SERVICE BULLETIN	
	Flight Design GmbH Sielminger Str. 51 D-70771 L.-Echterdingen Tel +49 (0)7021 / 80460-0 Fax +49 (0)7021 / 80460-69 E-Mail: airworthiness@flightdesign.com	SB-LTUL-CTLS-05 Revision 00

Rudder Centering Fork - Control Stop Replacement

SB-LTUL-CTLS-05

Fig. 1

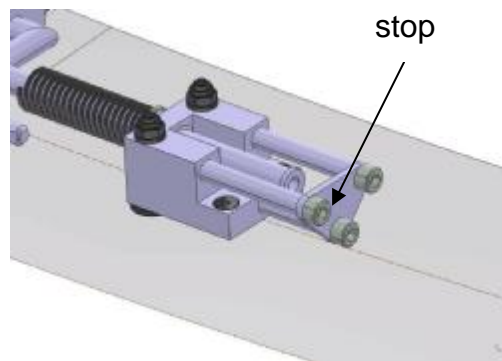
This is the rudder stop system that was installed to the CTLS affected by this SB ex factory. In this system the stop is provided to the rear end of the rudder centering fork, installed to the tunnel, below the instrument board. See following Fig. 1, 2 for illustration.

This system is the system affected by this SB.

Fig. 3

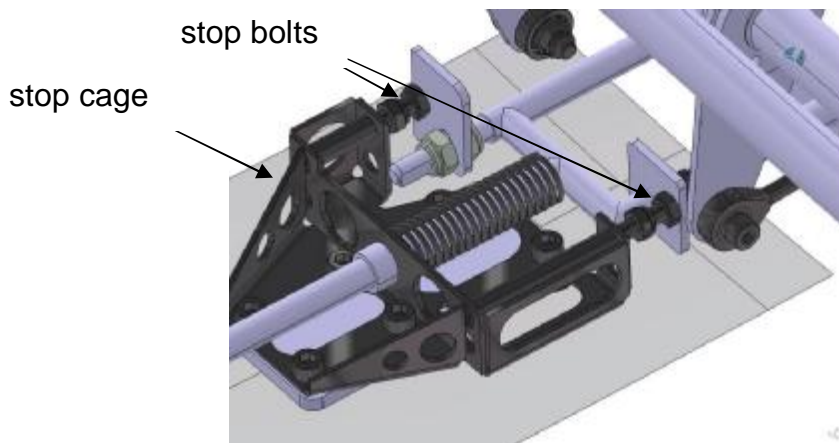
The new fork stop system provides a stop not to the rear end of the rudder centering fork, but to the thrust plates where the rudder centering fork contacts the bolt heads from the rudder pedal levers. The variant is clearly recognizable by the steel welded cage that provides the stops by means of adjustable bolts. See following Fig. 3 for illustration.

This stop device represents the valid type design and is used in serial production at the time of issuing of this SB. Only on aircrafts where the Rudder Stop Plates as by 3.1.3 cannot be used, this new fork stop system must be installed following this SB.

Fig. 10

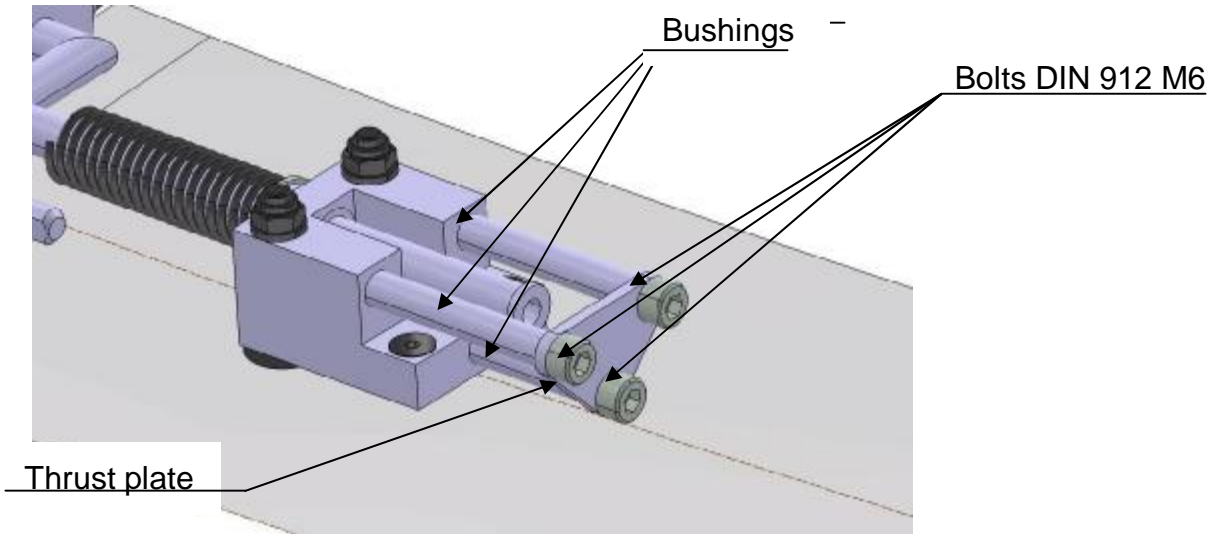
The old fork stop system, that guides the rear end of the rudder centering fork, must be uninstalled when the rudder stop plates are installed. To do this, remove the three bushings, bolts and thrust plate shown in Fig 10 from the fork mount block. Unscrew three (3) DIN 912 M6 bolts (Fig. 10). Discard these parts.

Fig. 11

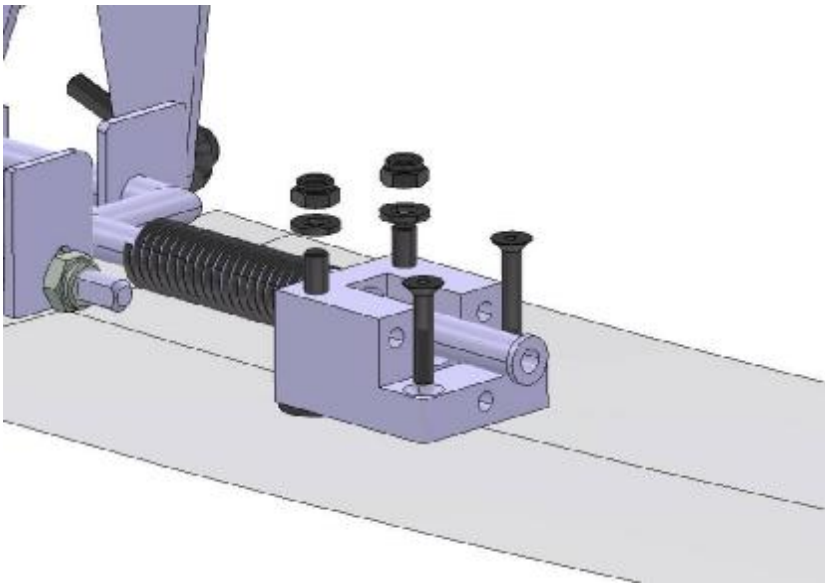
Remove the rear aluminum fork mount block from the lower fuselage skin by unscrewing the 4 bolts as shown in Fig. 11.

Warning: The spring installed to the rudder centering fork provides a pretension to the system and will push the aluminium block to the rear, once all bolts are removed.

Fig. 12

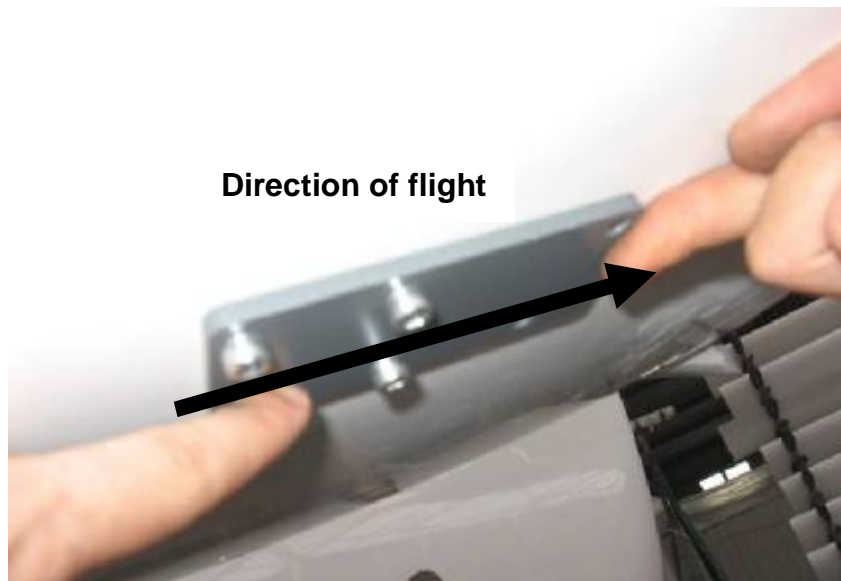
Bore out the four (4) existing holes from the outside bottom of fuselage to the new diameter Ø6mm.

Temporarily install PVC plate KF27200223 from the outside to the bottom fuselage using four (4) bolts (Fig. 12).

Warning: Installation must be exactly in the same position as the installation will be later on in the aircraft, so not turned upside down. When looking in direction of flight, the most forward hole on the left side must be rear of the most forward hole on the right side. Pay special attention, when drilling the holes you look from below. In case of doubt use the new fork stop cage to cross check. See Fig 6.

Fig. 13

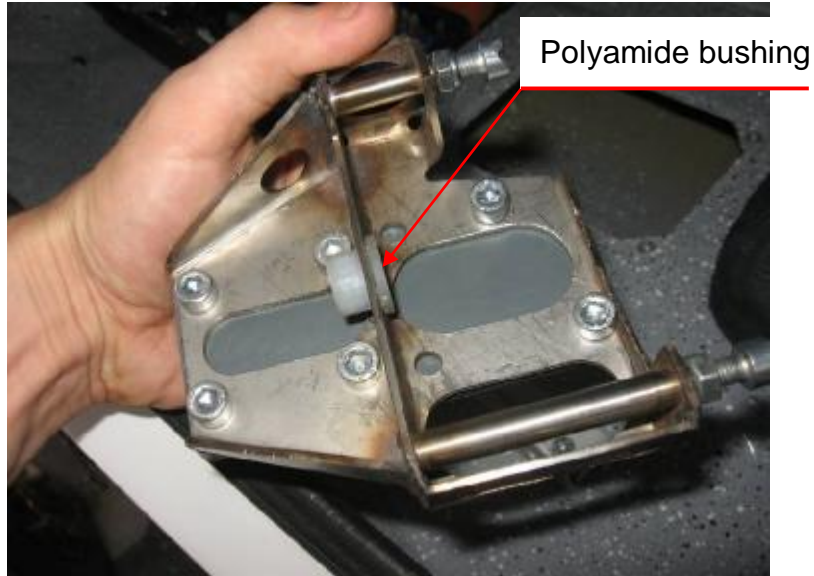
Remove polyamide bushing from the aluminum support that was uninstalled in step 3.3.3. Install this polyamide bushing to the guide hole of the new rudder stop device (Fig. 13).

Take the new fork stop system cage and place the PVC plate on the lower side and insert the 6 attachment bolts (Fig 13).

Fig. 14

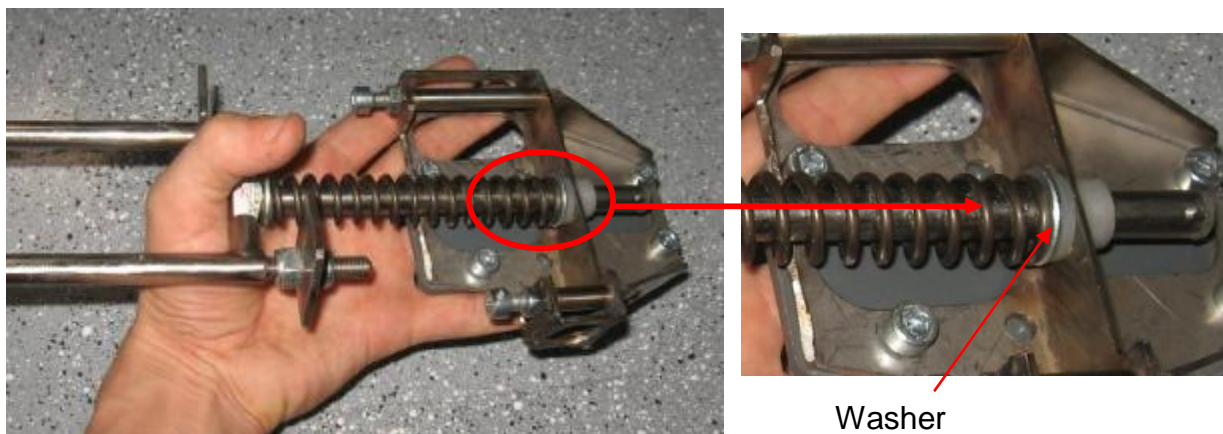
Insert rear guide of the rudder centering fork to the new fork stop system cage as shown in Fig 14.

Warning: Install one (1) washer between the spring and polyamide bush (Fig. 14)

Fig. 16

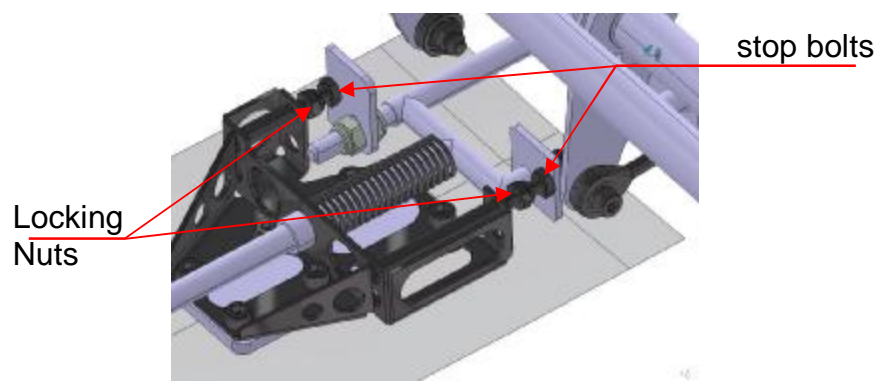
Adjustment of the rudder stops is achieved by changing the length of the stop bolts, inserted to the new fork stop system cage (Fig. 16). When deflected, the fork plates are pushed against these stop bolts. Changing both of the bolts allows increasing or decreasing the maximum rudder deflection.

Warning: The stops on both sides of the new system must be installed so that the stop at the side where the pedal is deflected touches the centering fork first or at the same time as the other side does. The opposite stop from the deflected pedal cannot touch first.

After finishing of the adjustment tighten the locking nuts (Fig 16) on the stop bolts.

Fig. 17

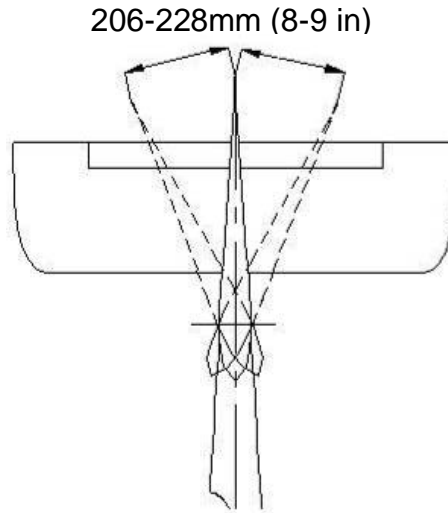
Maximum rudder deflection is measured at the lower trailing edge of the rudder as shown in Fig 17.
